Subject: NRC Request for Additional Information – April 7, 2008

**Response to NRC Request for Additional Information
Dated April 7, 2008**

**CE Windsor Site
Windsor, Connecticut**

**NRC License Number 06-00217-06
Docket Number 030-03754**

Figure 1
Interpreted Groundwater Contours
Potentiometric Map
October 2007

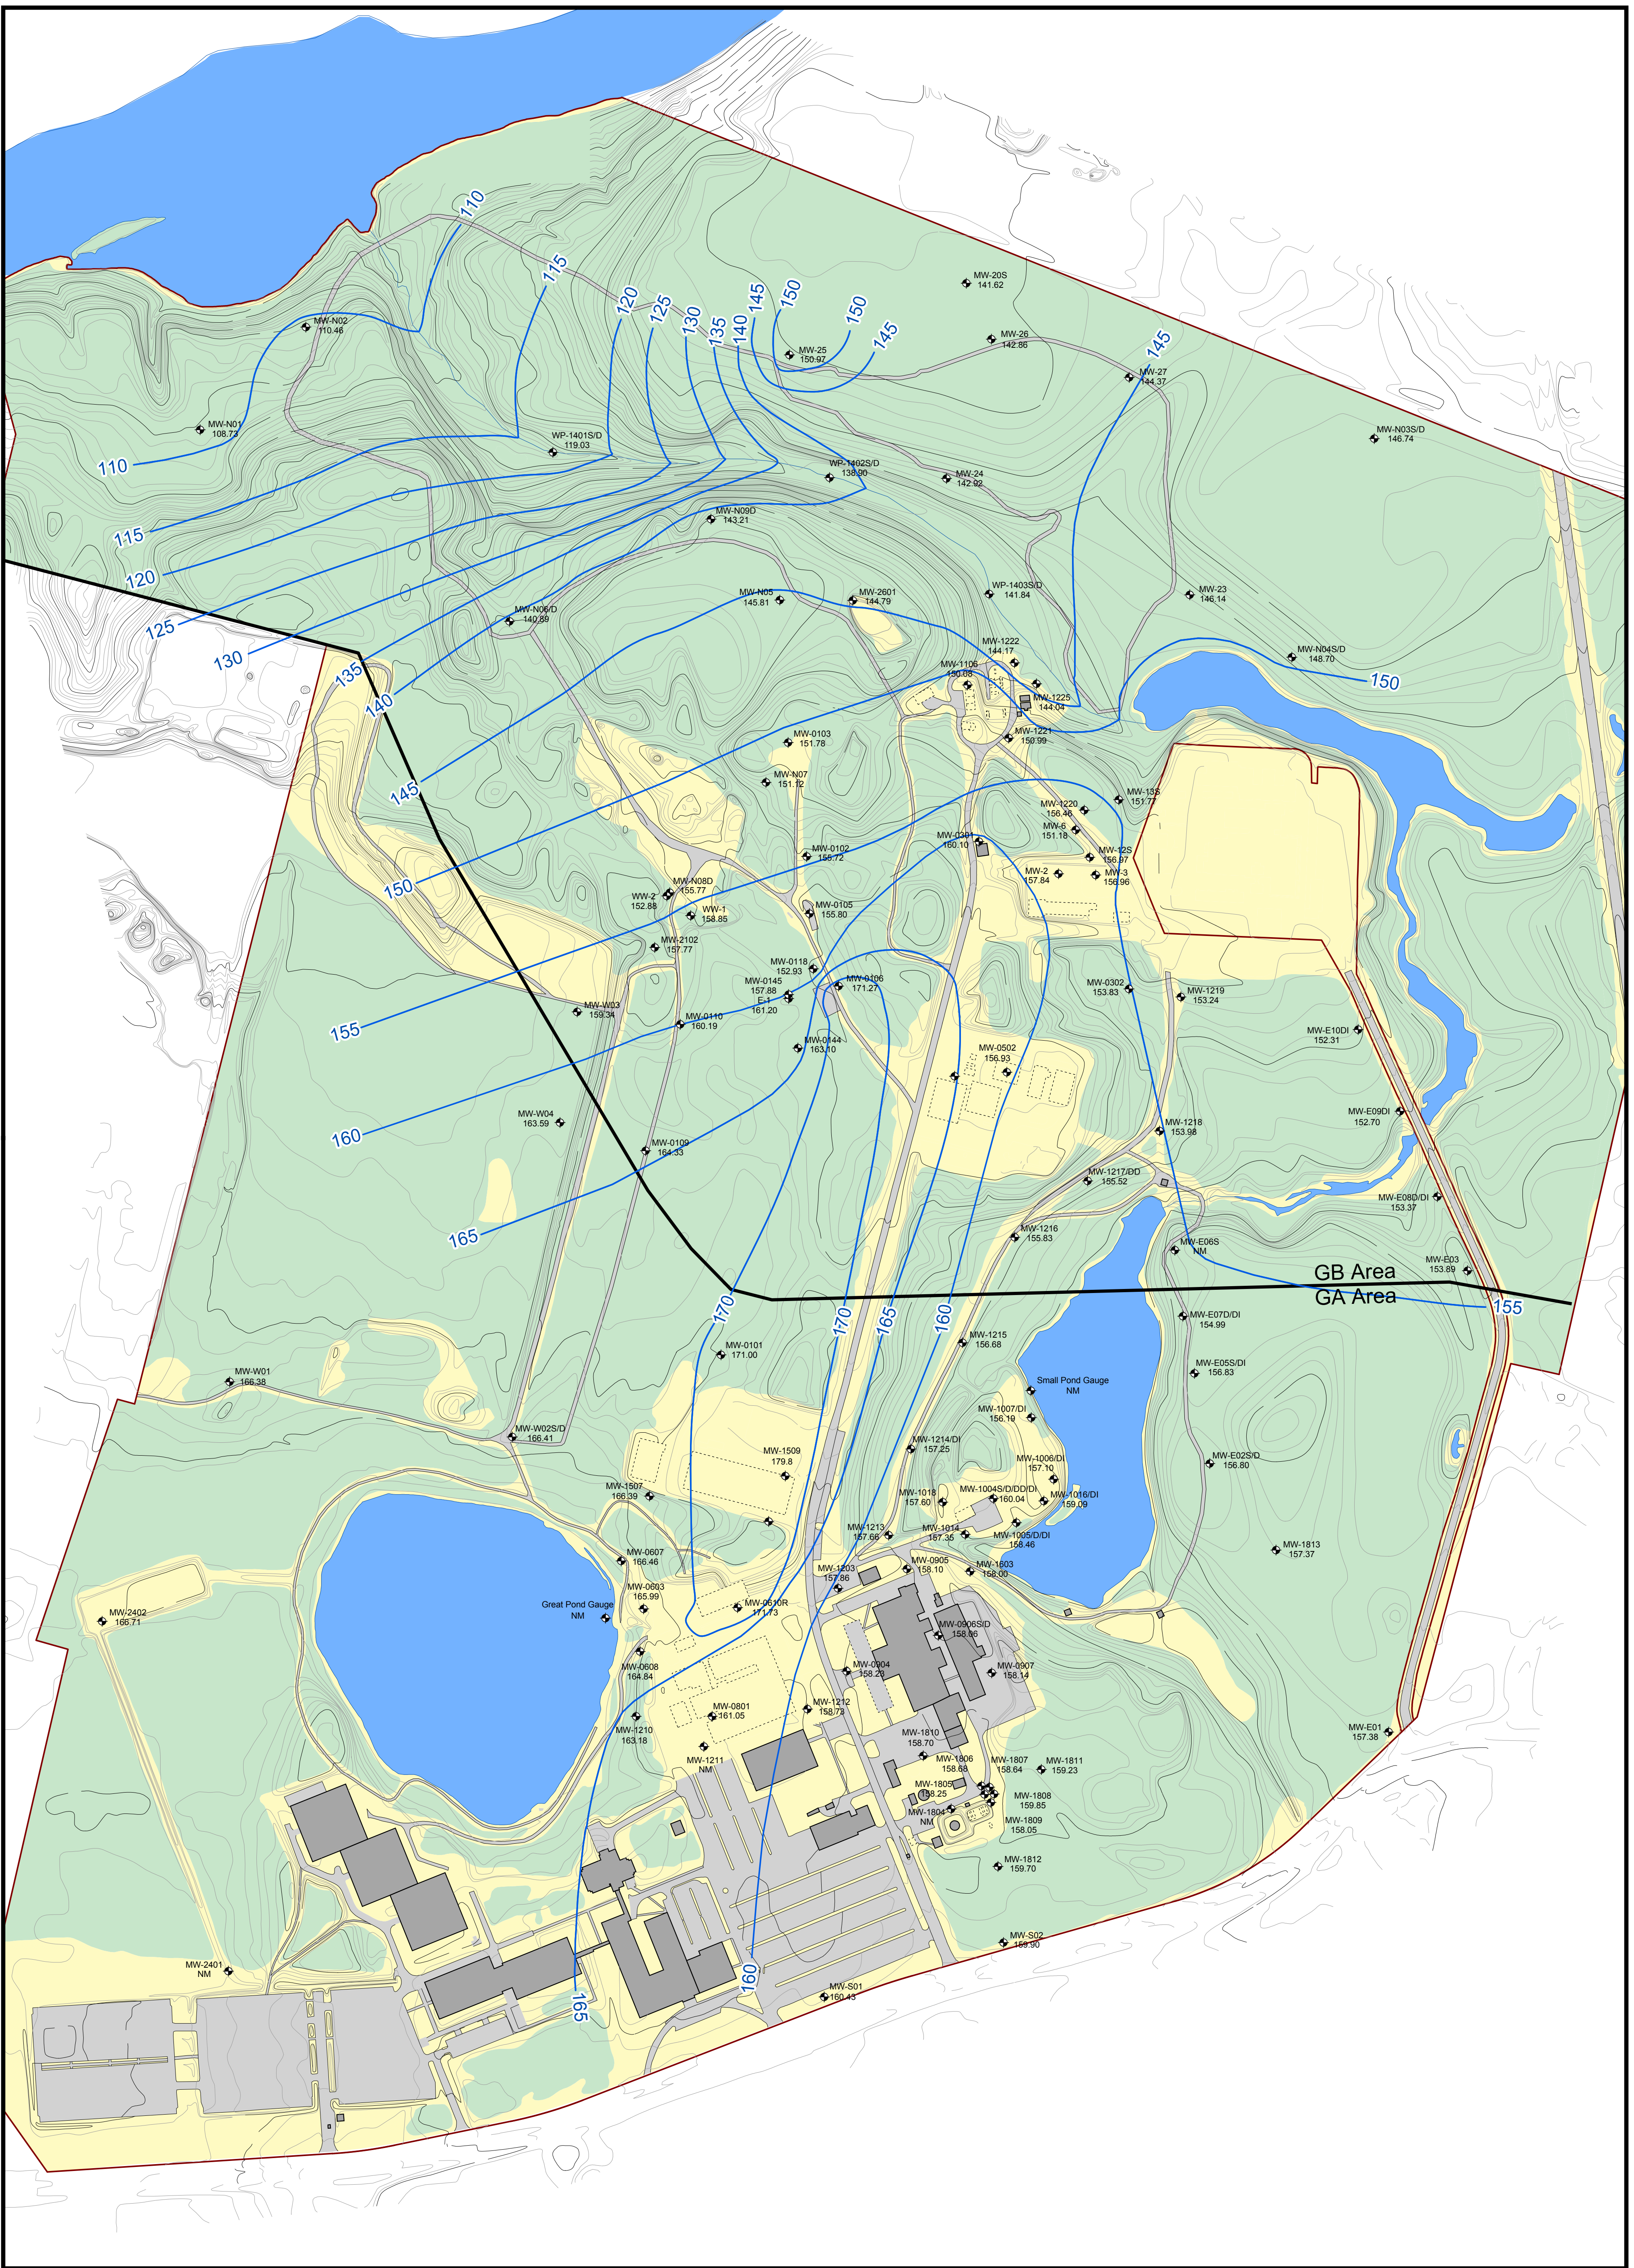
Please provide a radiological groundwater monitoring plan that will be used to demonstrate that activities described in the revised DP do not impact those areas expected to be released from the NRC license as requested. This plan should include the proposed monitoring sites, frequency of monitoring, a potentiometric map of the selected monitoring wells, and nuclides to be assessed.

Groundwater flow conditions vary across the Windsor Site. Recent interpreted groundwater contours (October 2007) and a potentiometric map are shown on attached Figure 1. In general, groundwater associated with the proposed remediation areas in the southern portion of the Site flows to the east-northeast. Groundwater associated with the central and northern portions of the Site flows to the northeast towards Goodwin Pond and to the northwest towards the Farmington River.

Groundwater associated with the Woods Area, Drum Burial Pit, Clamshell Pile, Burning Grounds, Debris Piles, and Site Brook flows to the northwest towards the Farmington River. The portions of the Windsor Site proposed for partial site release are located cross-gradient or upgradient of these remediation areas. Therefore, remediation of these areas of the Site will not impact groundwater conditions in the portions of the Windsor Site proposed for partial site release.
